Access Compliance Report

Public Rights-of-Way

(Curb Ramps)

Intersection ID: 11423	Main Street: S SUMMIT AV	Cross Street: W 4TH ST EXT	Location: NE
ADA ID: FF1063A5353D	Ramp Type: BlendTrans1	Initial Pass/Fail: Fail	Overall Compliance: No
		Severity Score: 1.25

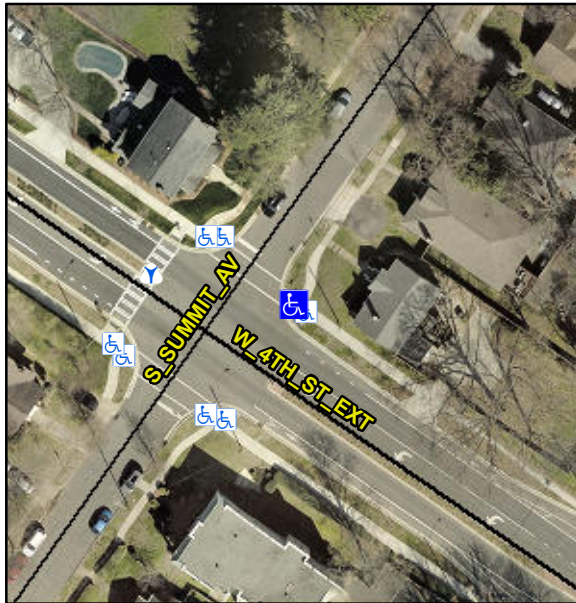
R304.5.3

Compliance	Description	Data	Compliance	Description	Data
N/A	Ramp Length (in)	44.0	Yes	BlendTrans Slope (%)	1.0
Yes	Ramp Width (in)	70.0	No	BlendTrans XSlope (%)	2.6
N/A	Flare Type LT	N/A	N/A	Flare Type RT	N/A
N/A	Flare Slope LT (%)	N/A	N/A	Flare Slope RT (%)	N/A
N/A	Flare Traversable LT?	N/A	N/A	Flare Traversable RT?	N/A
N/A	Landing Length (in)	N/A	N/A	DWS Provided?	N/A
N/A	Landing Width (in)	N/A	N/A	DWS Contrast?	N/A
N/A	Landing Slope (%)	N/A	N/A	DWS Length (in)	N/A
N/A	Landing X Slope (%)	N/A	N/A	DWS Full Width?	N/A
N/A	Landing Curb? (Y/N)	N/A	N/A	DWS Offset (in)	N/A
N/A	Shared Landing?	N/A			
N/A	Gutter Ponding?	N/A	N/A	Gutter Slope (%)	N/A
N/A	Gutter Lip Ht (in)	N/A	N/A	Gutter X Slope (%)	N/A
N/A	Painted X Walk1?	No	N/A	Painted X Walk2?	N/A
	X Walk 1 Direction	To NW		X Walk 2 Direction	N/A
	X Walk 1 Width (in)	N/A		X Walk 2 Width (in)	N/A
	X Walk 1 Slope (%)	4.0		X Walk 2 Slope (%)	N/A
	X Walk 1 X Slope (%)	2.7		X Walk 2 X Slope (%)	N/A

Remove & Replace Curb Ramp With Two New Directional Ramps or Equivalent.
